***Waynflete Arts Center***  
***Phase Two***  
***July 3, 2007***

**MEMORANDUM Site Plan Punchlist Memorandum**

**date:** July 3, 2007  
**project:** WAYNFLETE ARTS CENTER, PHASE TWO, 2003-0040  
**re:** Major Development, Site Plan Punchlist questions of May 31, 2007  
**to:** Shukria Wiar  
Planning Department City of Portland  
**from:** Austin Smith Scott Simons Architects (SSA)  
**cc:** Scott Simons SSA  
Charles Young SSA  
Anne Hagstrom Waynflete  
David Cimino Stroudwater

2007 © Scott Simons Architects  
DWG NO. L-1.1

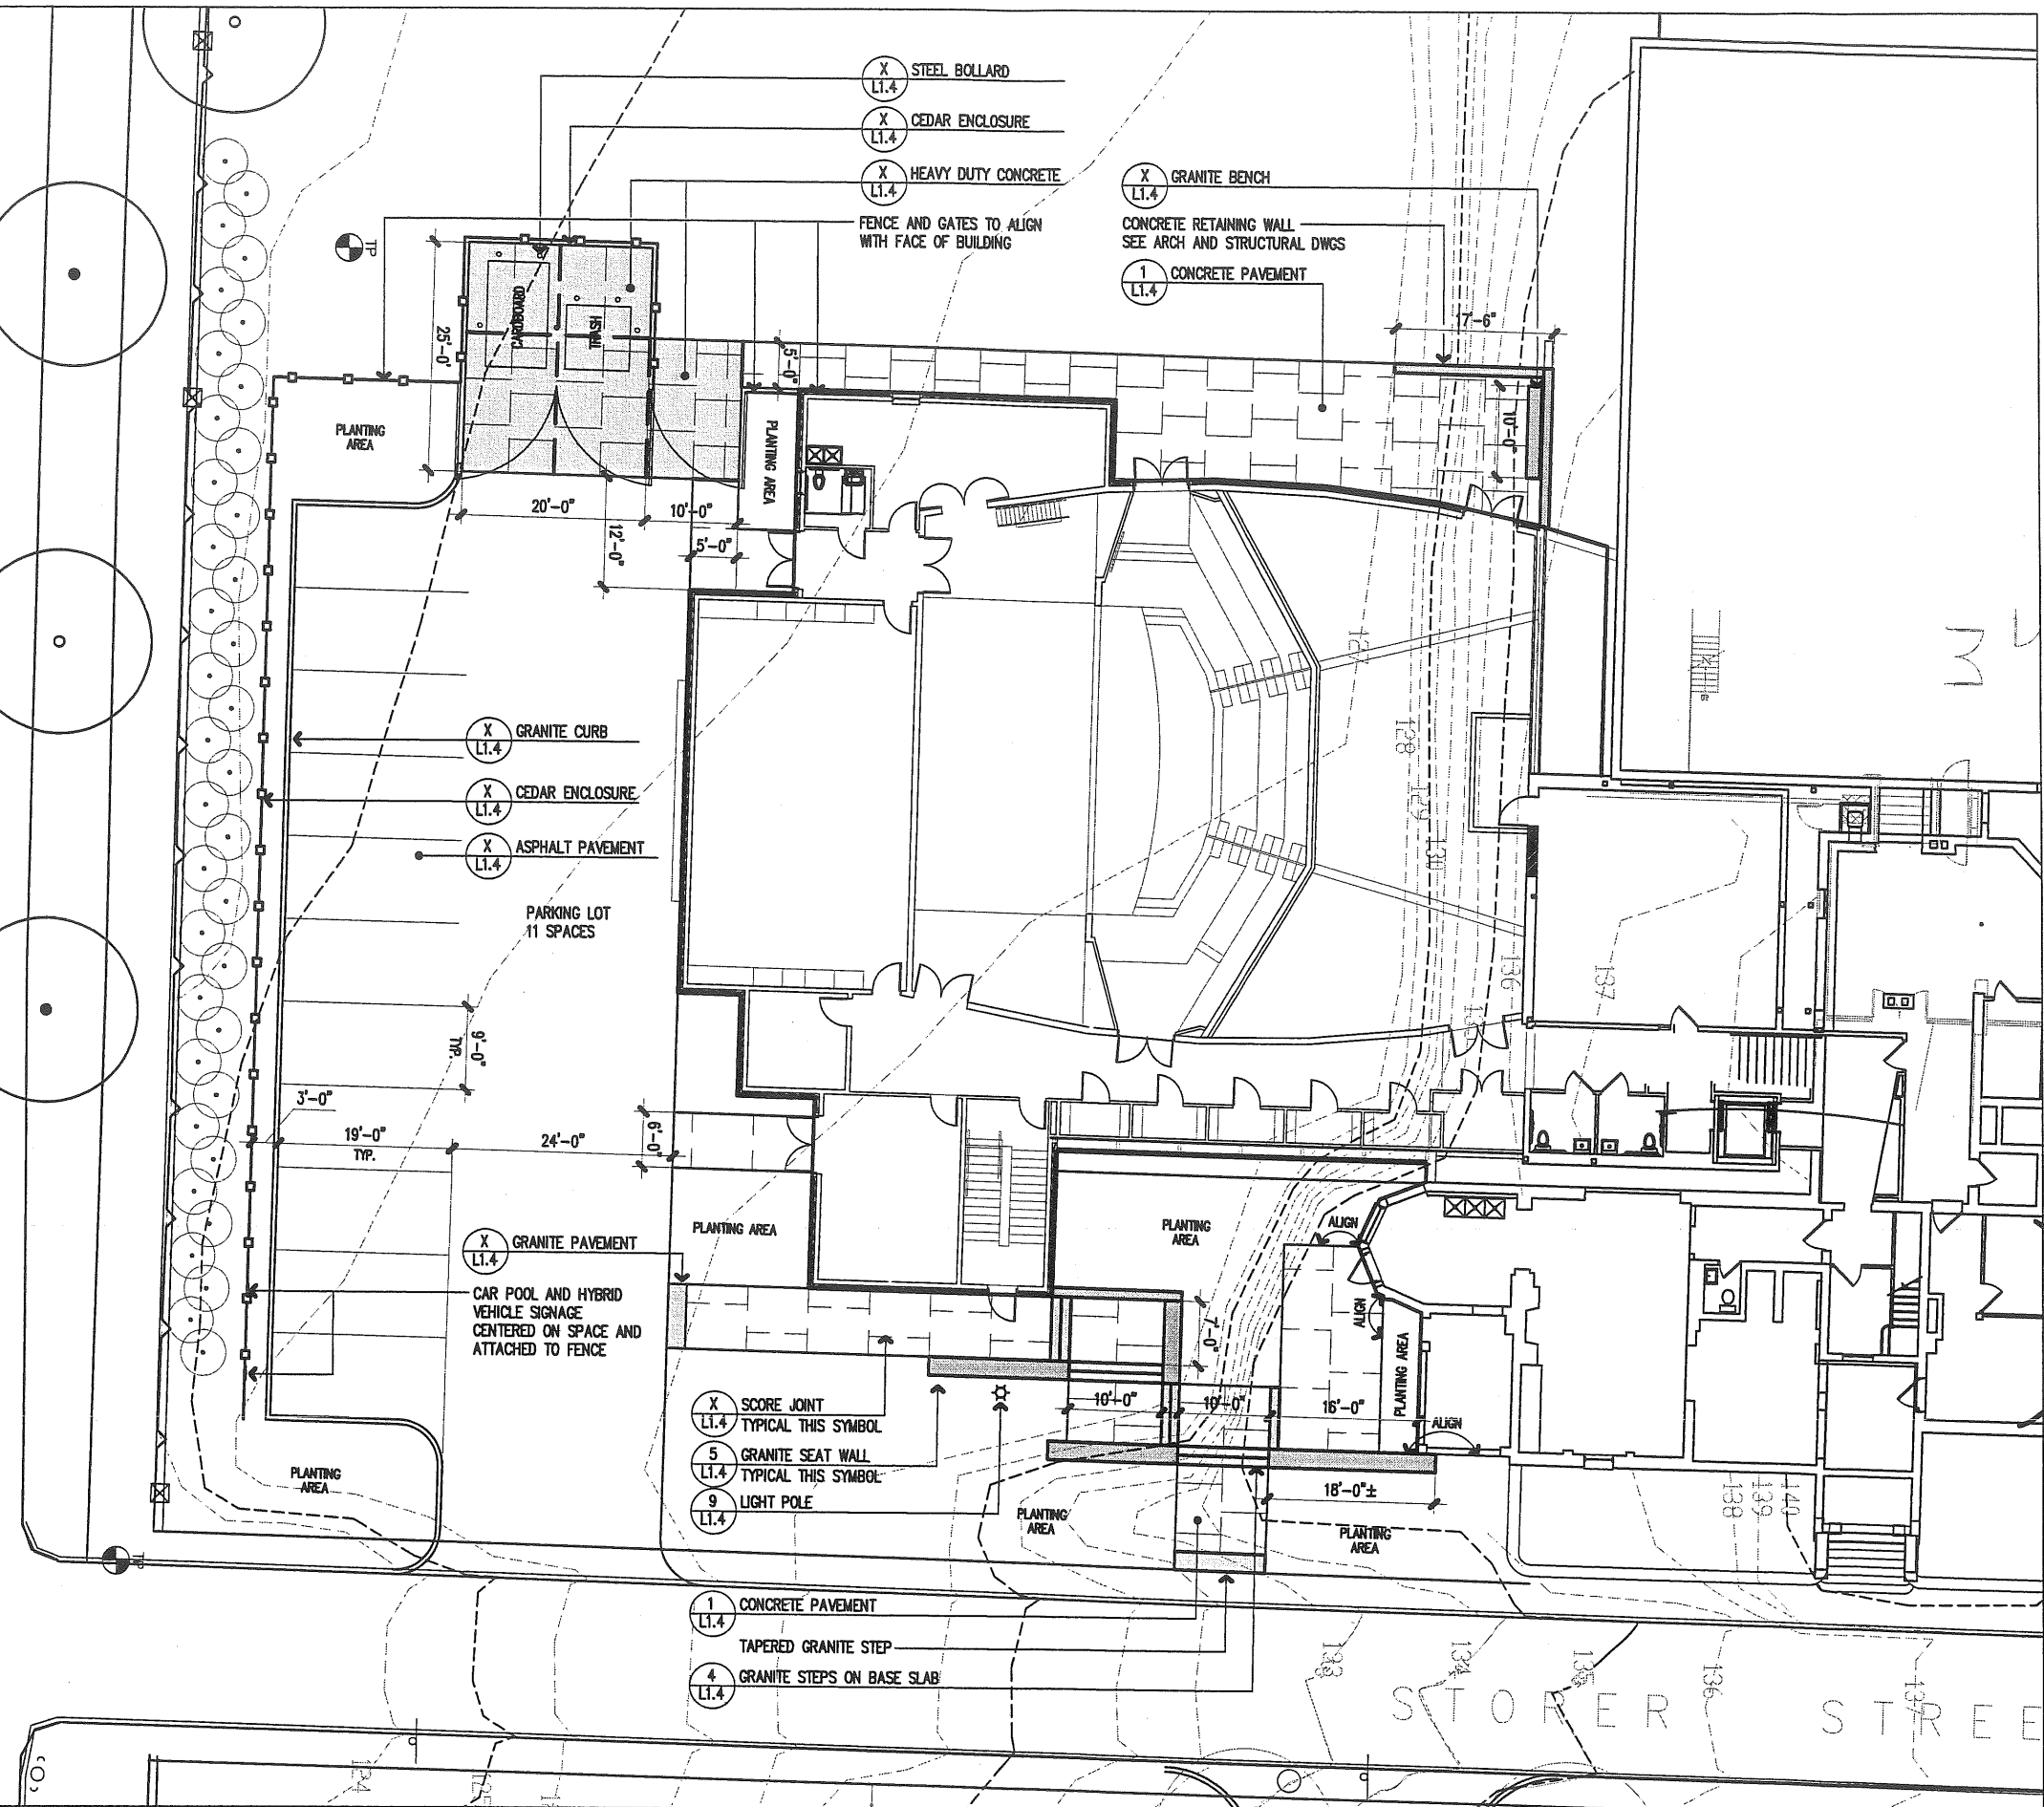
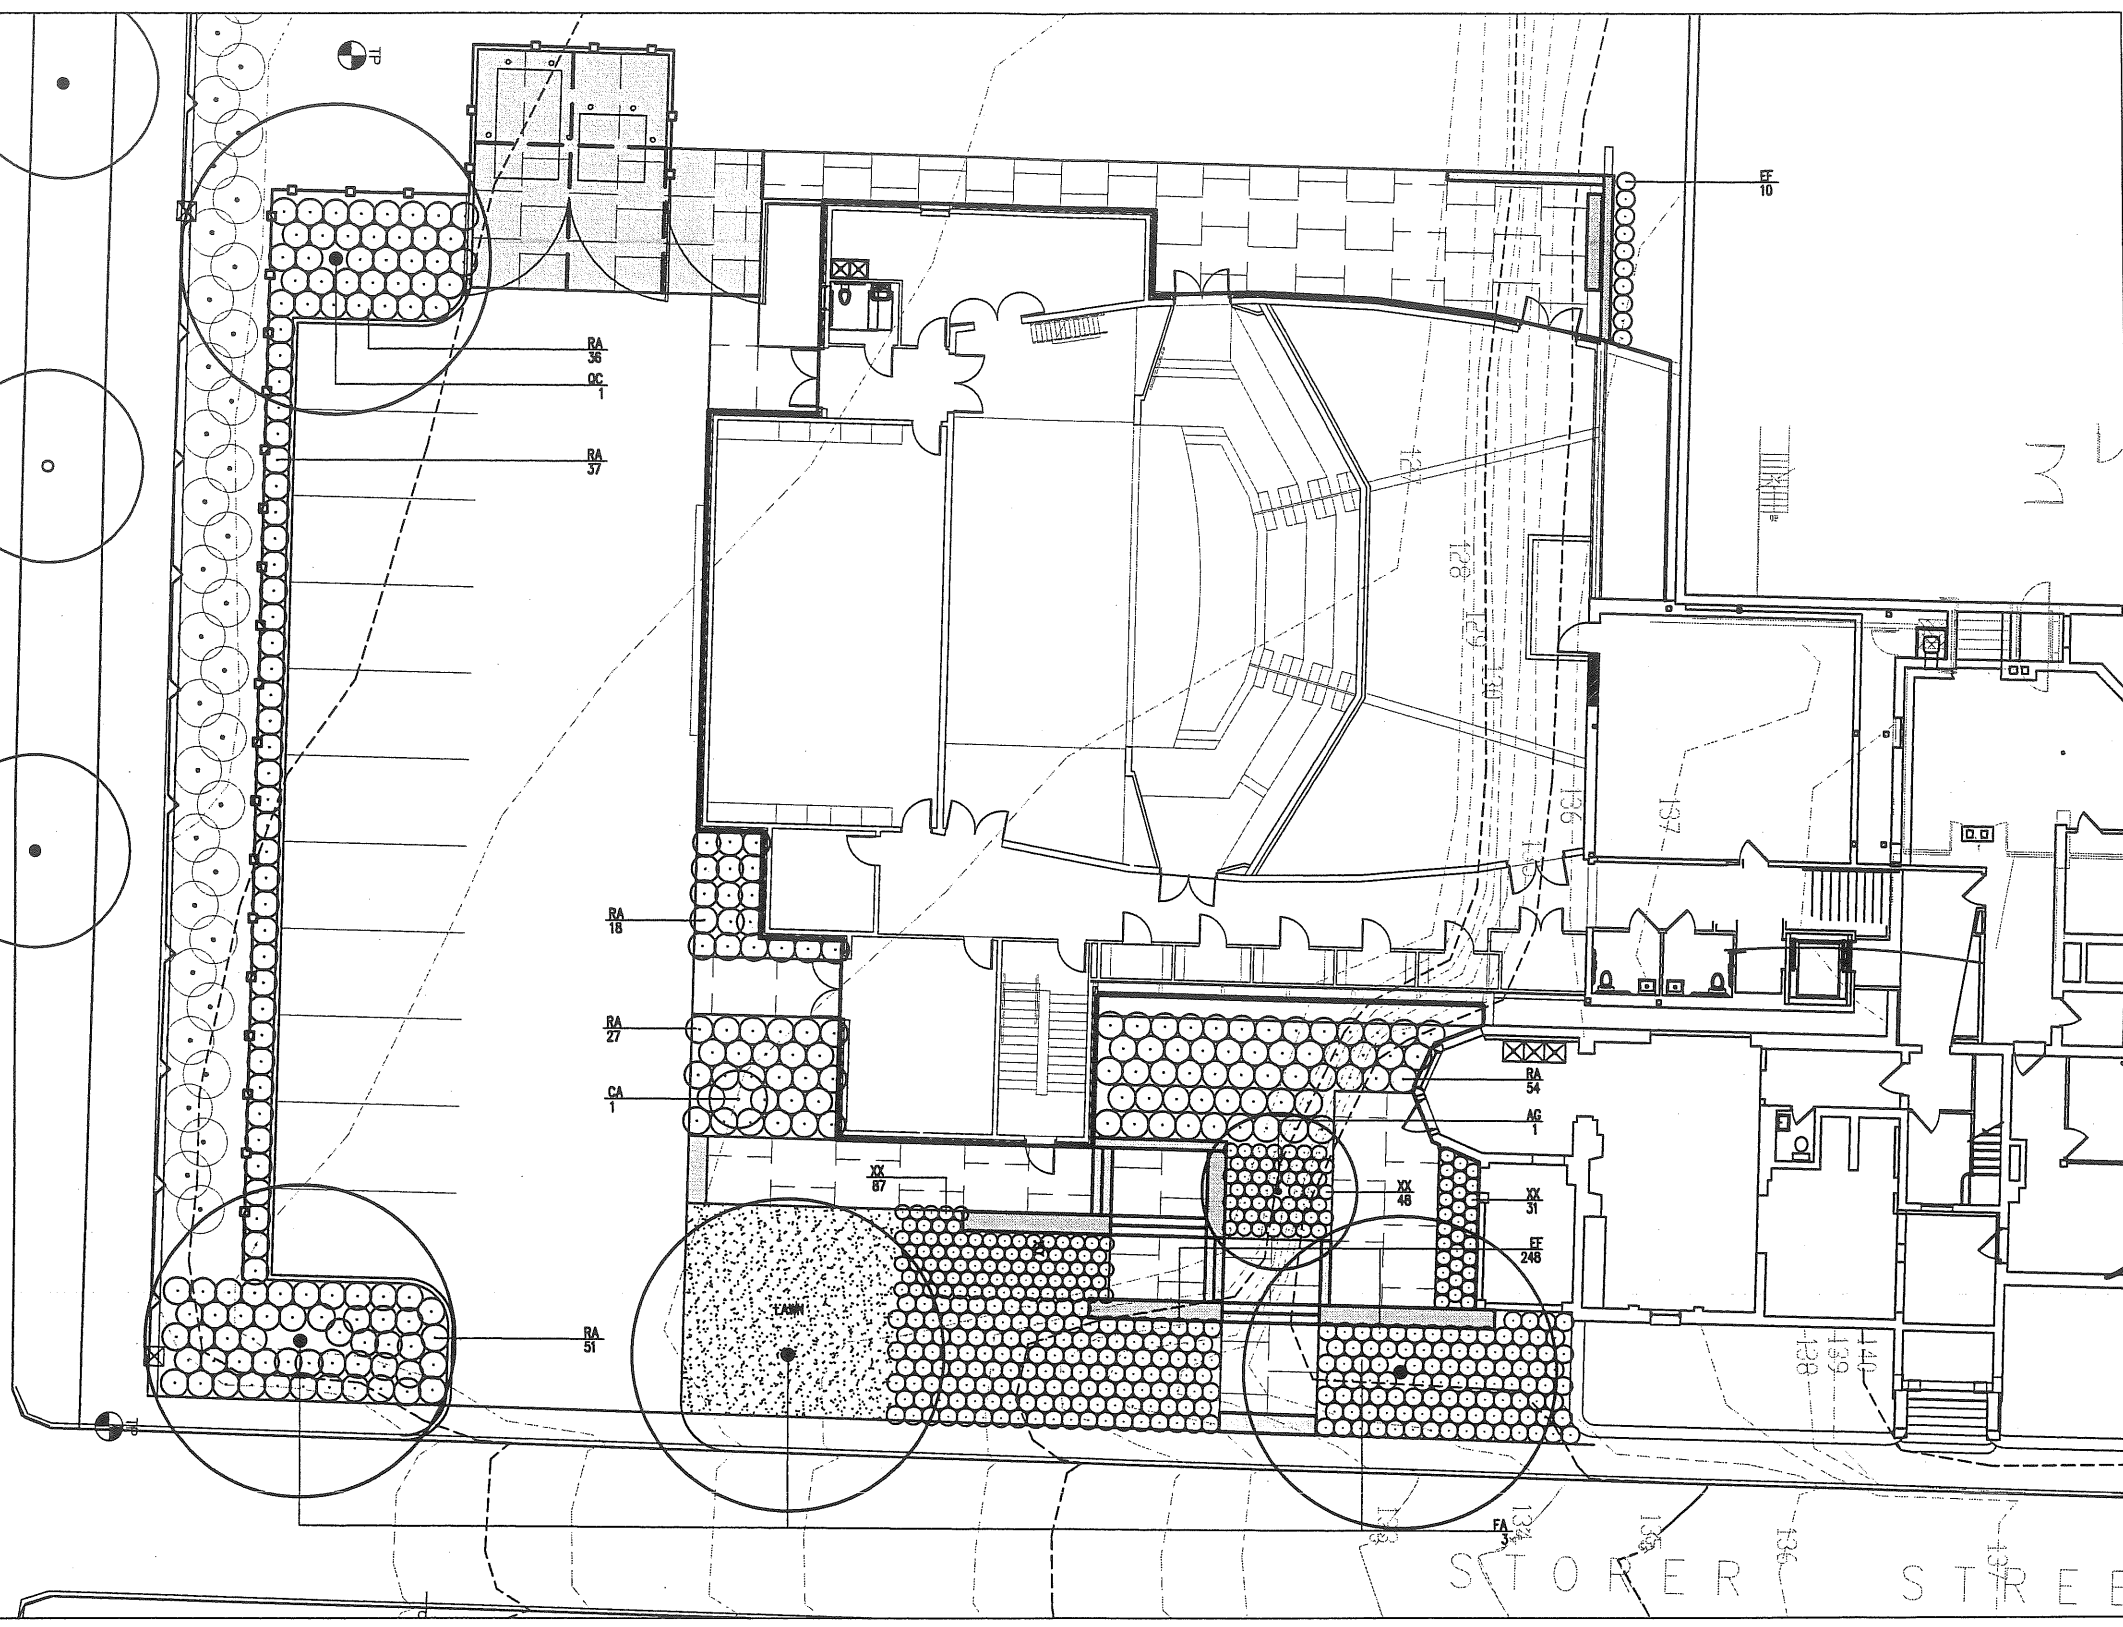
4. According to the City's Technical and Design Standards and Guideline, Section 2 (A) (b), a two way drive shall be 24' and the site plans shows 20'. The applicant can request a formal waiver of this standard.

5. According to the City's Technical and Design Standards and Guidelines, Section 3(A), Parking stalls shall be 9' x 19'. Please show this on the site plan or submit a waiver of the standard.

Driveway width increased to 24', reflected on enclosed drawing L-1.1 dated July 2, 2007

Current drawings revised to include 9' x 19' parking stall complying with city standards.  
See revised drawing L-1.1, dated July 2, 2007.
